**CITRUS COUNTY CENTRAL LANDFILL
SITE ASSESSMENT REPORT
IN ACCORDANCE WITH
CHAPTER 62-780.600(8) FAC**

**RESPONSE TO FDEP REQUEST
FOR ADDITIONAL INFORMATION**

January 2009

Figure 1: Carbon Dioxide Measurements from the GS(N) Series Probes

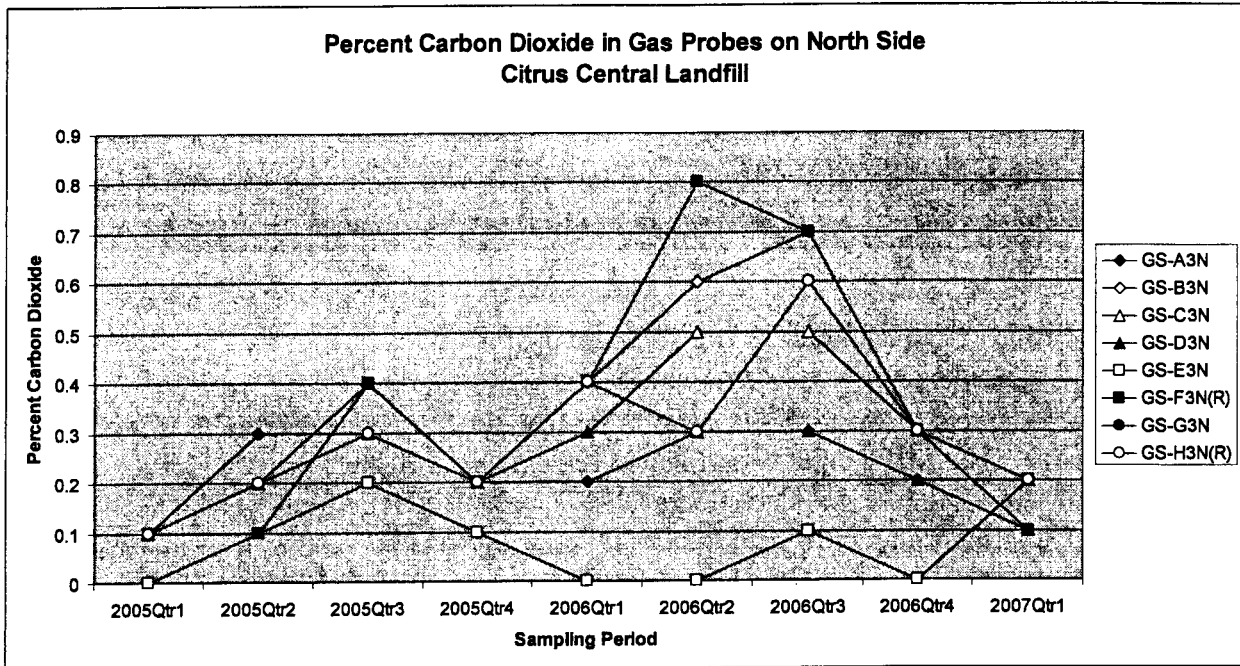
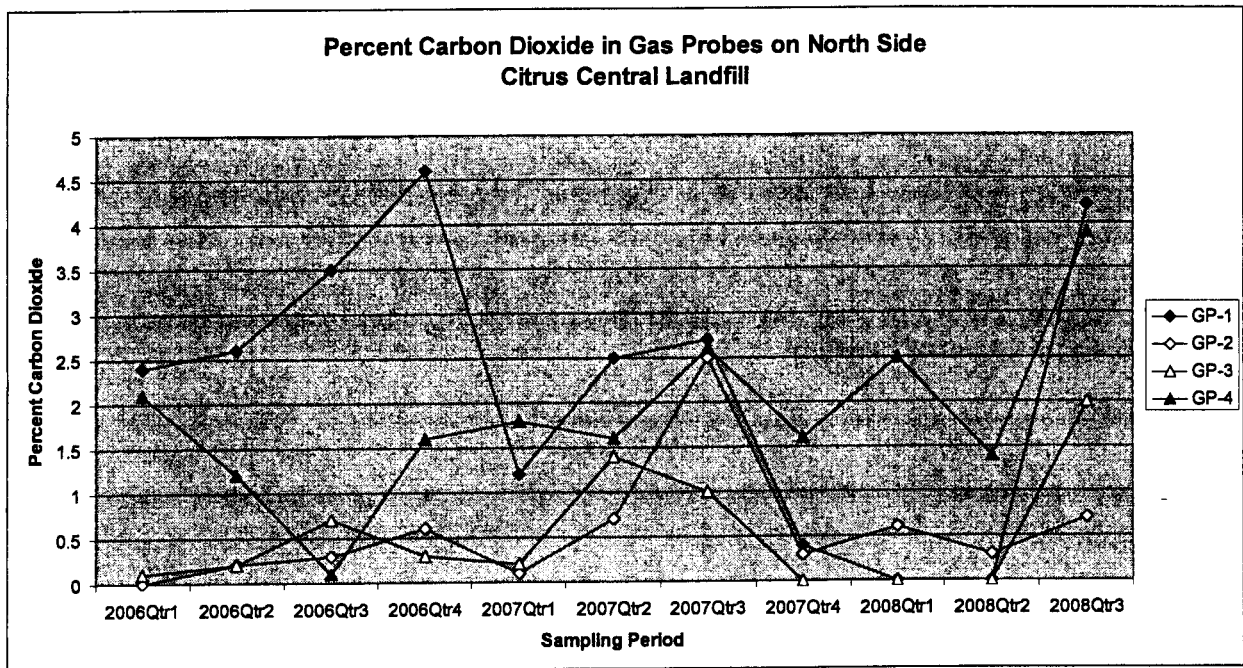
Comment 1: The SAR does not adequately determine or confirm the origin of the source of contamination as per Rule 62-780.600(3)(c), F.A.C. Although the SAR indicates that landfill gas is the source of contamination of groundwater in the vicinity of compliance well MW- 10, information was not provided to support this conclusion, such as:

- a. Data to demonstrate that landfill gas is present in the vicinity of compliance well MW-10;*
- b. If landfill gas is present, a proposed pathway and supporting calculations that demonstrates that the volume of landfill gas is sufficient to cause groundwater quality impacts in the vicinity of MW-10;*
- c. Analytical results that demonstrate that volatile organic compounds in landfill gas are similar to those in groundwater in the affected area.*

Carbon Dioxide concentrations in vadose gases along the north side of the closed (60-acre) site range from 0 to 4.5 %. Most vadose gases include less than 0.1 % Carbon Dioxide. The measurement of this gas at the property boundary indicates that landfill gas is migrating nearly 400 feet beyond the solid waste boundary in the vicinity of MW-10.

Figure 3: Benzene, Vinyl Chloride, and Total VOC trends in MW-10

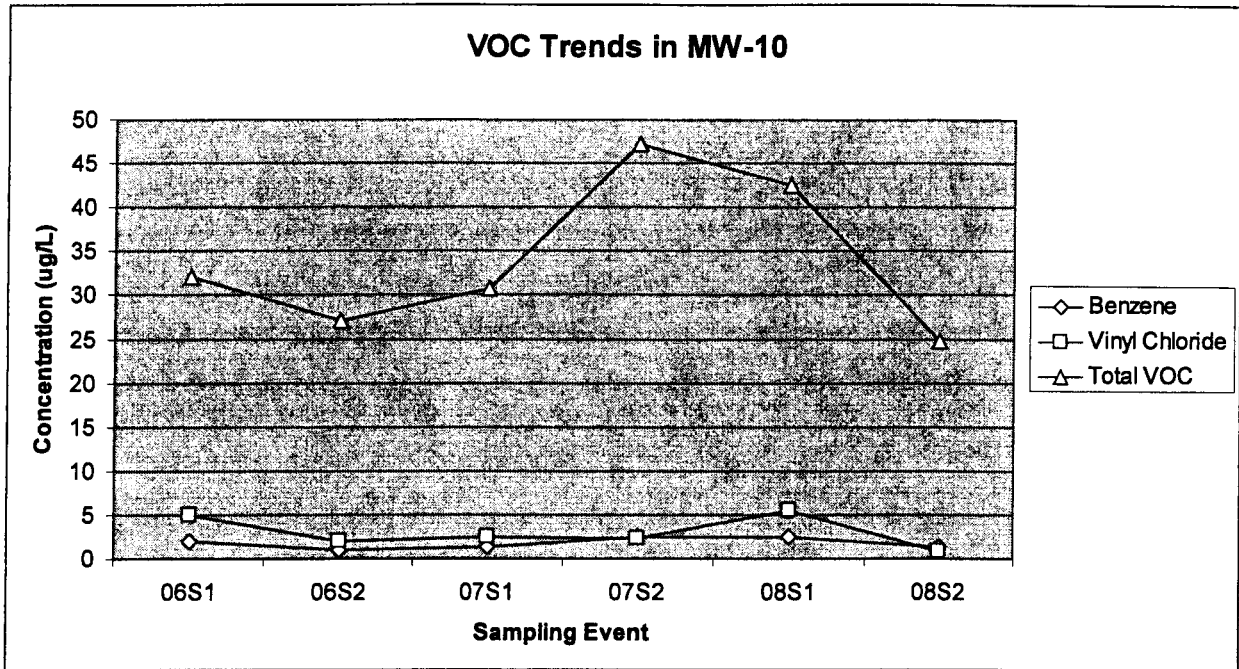
Comment 2: The monitoring data reported through the January/March 2008 sampling events do not show an overall decrease in contamination, as required by Rule 62-780.690(l)(e), F.A.C.

Response 2: A Natural Attenuation with Monitoring rehabilitation strategy through Rule 62-780.690 FAC requires the Site Assessment Report (SAR) to include data that show an overall decrease in the contamination. While the direct measurements of contaminants at MW-10 and other wells onsite that are impacted by landfill gas (such as MW-17 and MW-15) do not show an overall decrease in concentrations, other data, such as modeling to predict landfill gas generation, may provide the required evaluation to allow a natural attenuation strategy.

Benzene compared to the total VOC detections in MW-10. Vinyl Chloride and Benzene are detected consistently above the Florida Groundwater Standard (1.0 ug/L), but the detections are low and seem to show no discernable upward or downward trend. This is supported by the trend of the total VOCs.

**FIGURE 5--1
CONTAMINATION LOCATION MAP
CITRUS COUNTY LANDFILL**

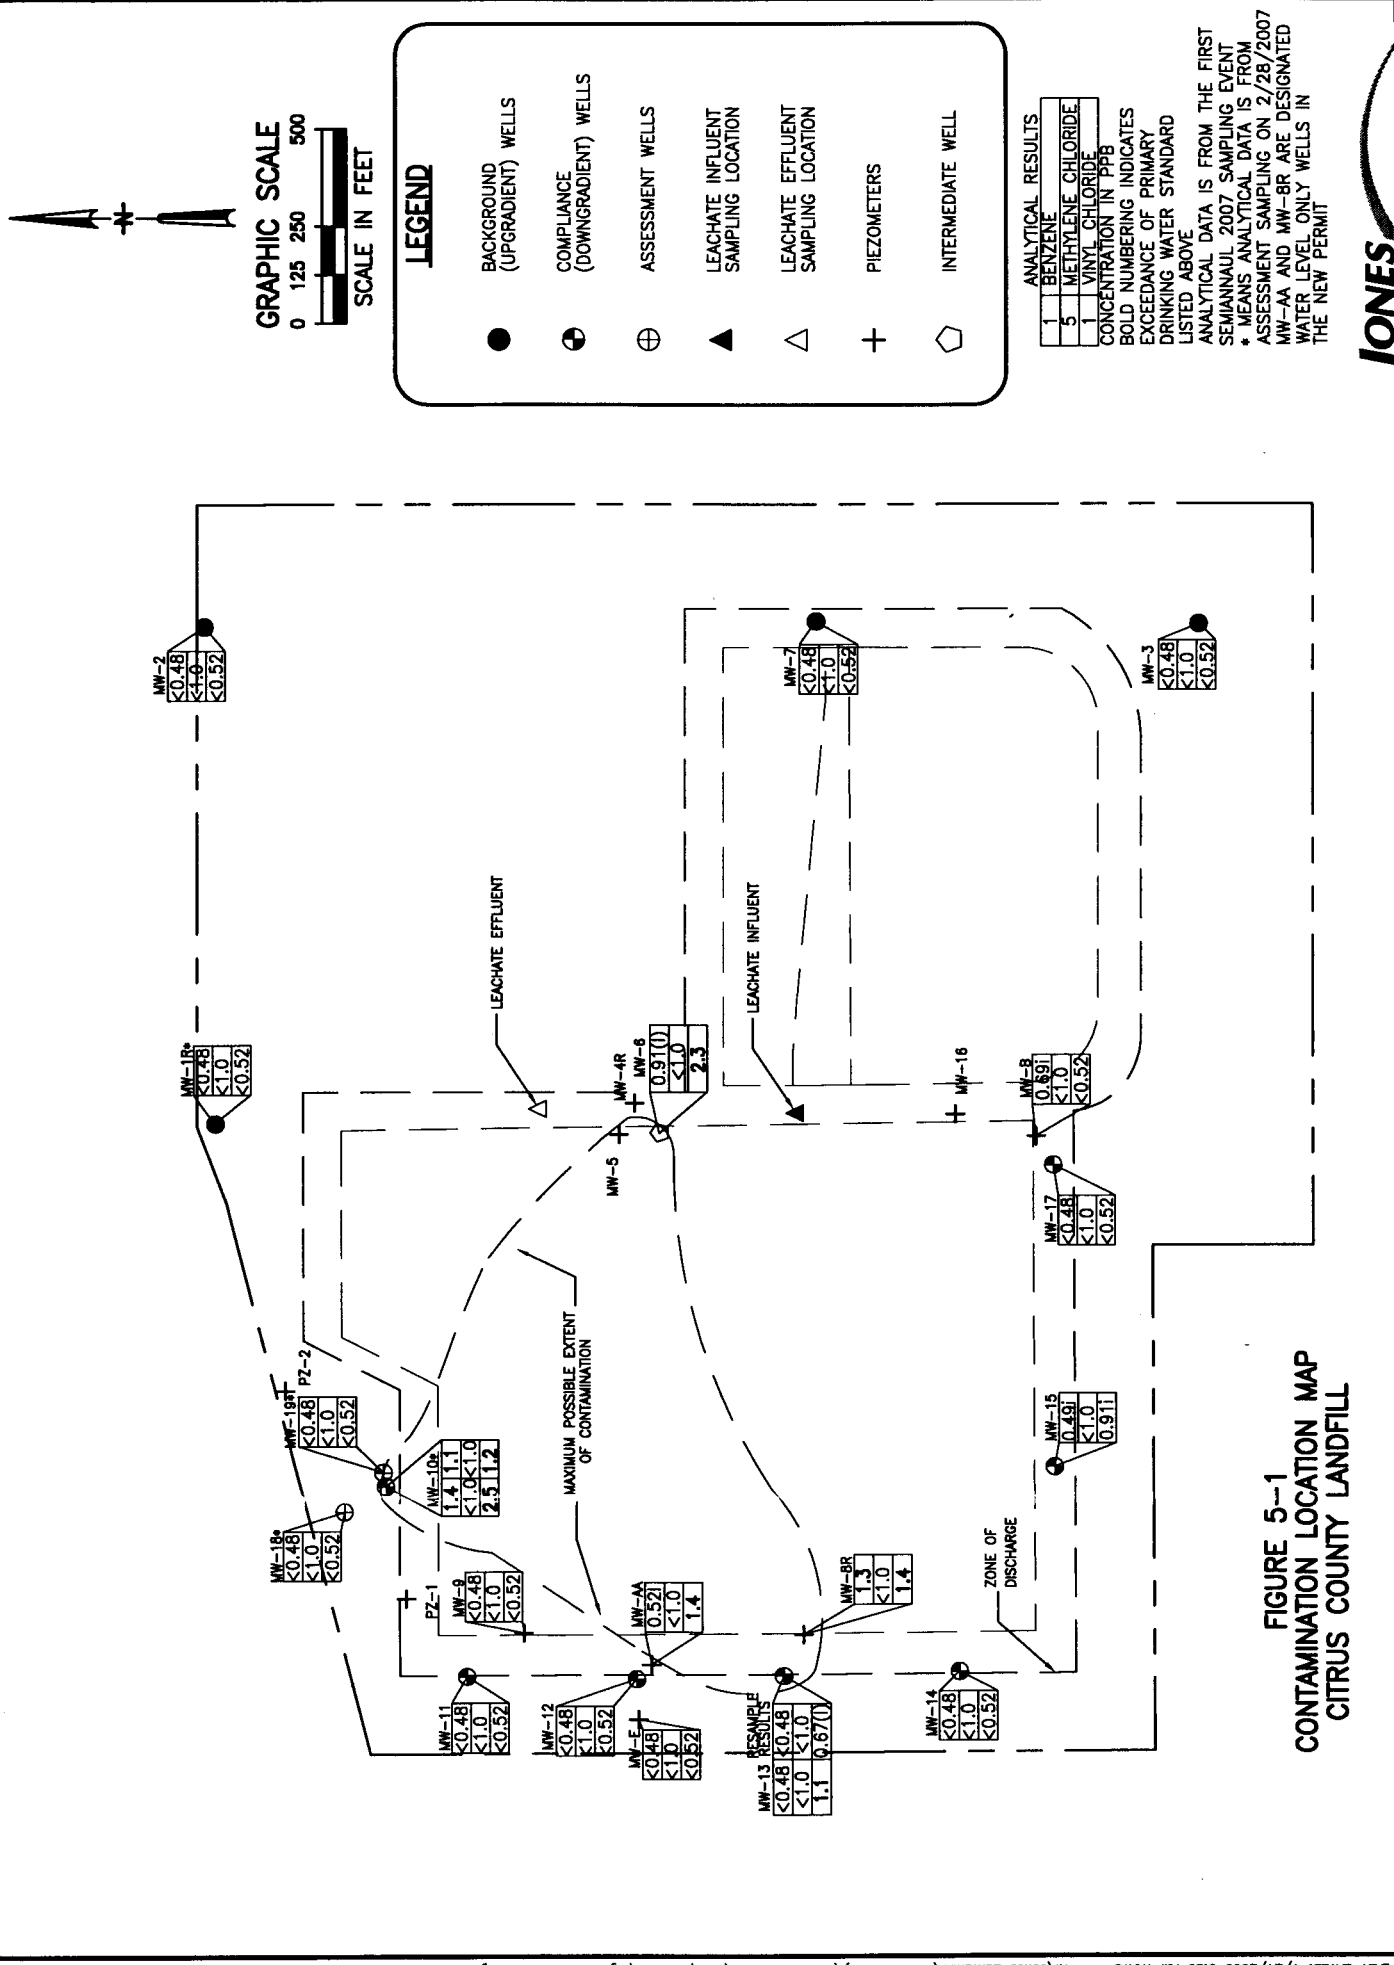
Comment 3: Figure 5-1 was indicated to present the contaminant concentrations for ground water samples collected in January and February 2007, however Figure 5-1 does not present the following:

Response 3.a: Figure 5.1 has been changed to include the results of both sampling events. The new Figure 5.1 is included in Attachment 3. Also included in Attachment 3 are Figures 5.1.b and 5.1.c. Figure 5.1.b shows the maximum reported concentrations of Benzene, Methylene Chloride, and Vinyl Chloride measured in each well between the first semiannual 2007 and second semiannual 2008 sampling events. Figure 5.1.c shows the reported concentration of Benzene, Methylene Chloride, and Vinyl Chloride measured during the most recent sampling event, the second semiannual 2008.

Response 3.b: Figure 5.1 has been changed to include the results of the January sampling event collected from MW-13. The new Figure 5.1 is included in Attachment 3.

Response 3.c: Figure 5.1 has been changed to show the correct results for MW-15 during the January 2007 sampling event. The new Figure 5.1 is included in Attachment 3.

Response 3.d: Figure 5.1 has been changed to show the correct results for MW-B during the January 2007 sampling event. The new Figure 5.1 is included in Attachment 3.

ATTACHMENT 12
MW-18 SLUG TESTS

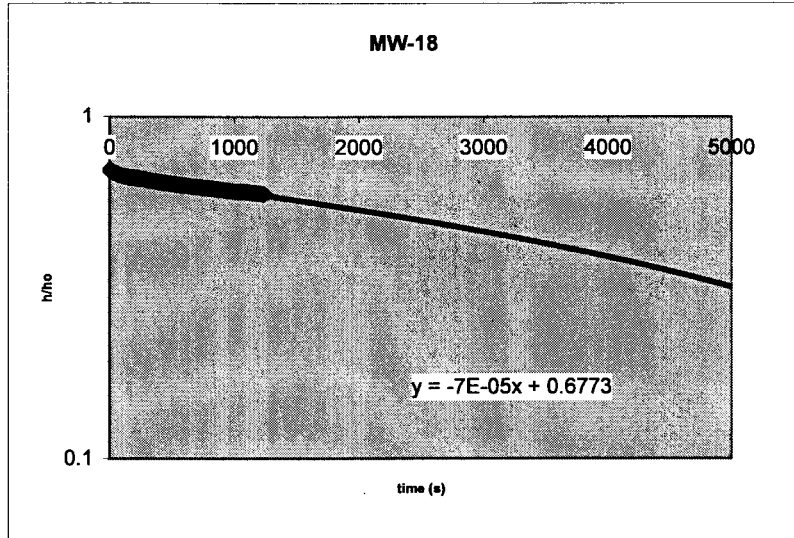
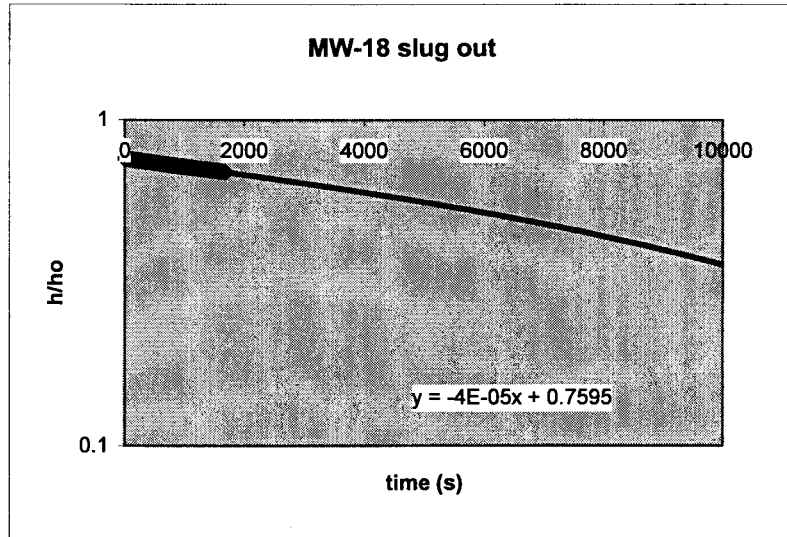
Comment 12: Table 12-1 included a note that "MW-18s time at 37% was calculated using trendlines as the data was good although the tests were not allowed to run to completion; however the trendlines for the "slug-in" and "slug-out" tests conducted at MW-18 were not provided in Appendix C of the SAR.

Response 12: The graphs for the slug in and slug out of MW-18 have been expanded to show the trendlines. The first page of the data for the slug-in and slug-out tests for MW-18 that shows the graphs is included as Attachment 12.

Figure 19-1
 Cross-Section between MW-11 and PZ-2 at the Citrus Central Landfill

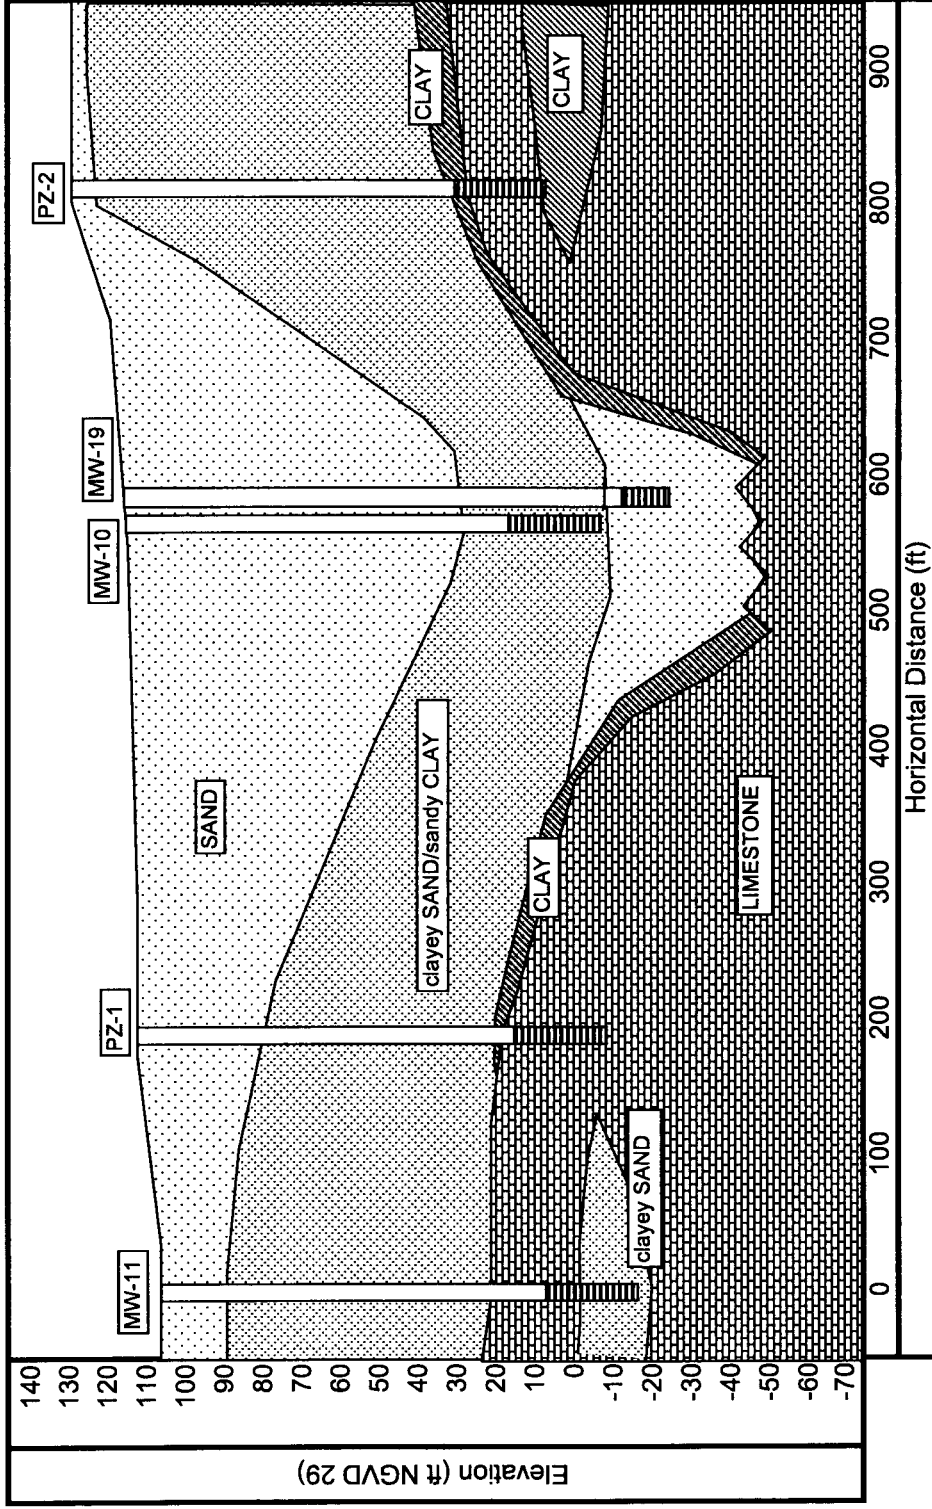
Comment 19: Figures 17-1 and 17-2 appear to depict the contact between the sand/clayey sand sediments and the limestone sediments based on the first occurrence of limestone. These figures do not depict the stratigraphy encountered at MW-11, MW-12, MW-13 and PZ-2 where clayey sand, sandy clay, silty clay, or clay were reported below the uppermost limestone.

Response 19: The figures were created to show the highly irregular limestone contact observed across the site. Attachment 19 includes two cross-sections, one from the western boundary and one from the assessment area around MW-10 looking north. These cross-sections display a finer detail than those submitted in the original SAR document.
